APPLICATION NO.	FILING DATE	FIRST NAMED INVENTOR	ATTORNEY DOCKET NO.	CONFIRMATION NO.
10/657,483	09/08/2003	Brian E. Curcio	END920000122US3 (IEN-10-5)	7494
26681	7590	10/26/2006	EXAMINER OLSEN, ALLAN W	
DRIGGS, HOGG & FRY CO. L.P.A. 38500 CHARDON ROAD DEPT. IEN WILLOUGHBY HILLS, OH 44094			ART UNIT 1763	PAPER NUMBER

Advisory Action Before the Filing of an Appeal Brief	Application No. 10/657,483	Applicant(s) CURCIO ET AL.	
	Examiner Allan Olsen	Art Unit 1763

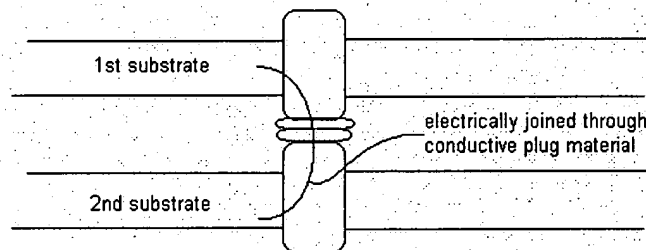
With respect to claim 20, the proposed amendment addressed the issue set forth in the FINAL Office action but in so doing created new 112 issues. For example, the newly added "forming an opening through the coating" should read something like, --forming a second opening through the second coated substrate--. Regarding applicants arguments pertaining to Asai, for example with respect to claim 19, applicant argues that because layers 6 and 7 of Asai overlie plug 5, Asai cannot teach or suggest joining two nubs from different substrates. The examiner notes layers 6 and 7 of Asai are conductive layers. As such when Asia removes the conductive coating from a face of the dielectric substrate Asia meets the claimed step of "removing at least a portion of the surface of the conductive coating on at least one face of the first dielectric substrate to form a first nub of conductive material. Regarding claim 1, see following figures.

Applicant's arguments relate to this structure

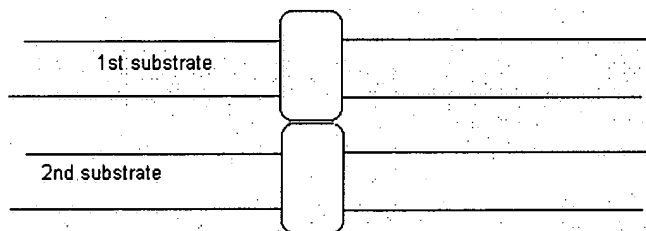
Asai teaches the above structure in which the electrical connection between the 1st and 2nd substrates goes through their respective plug material
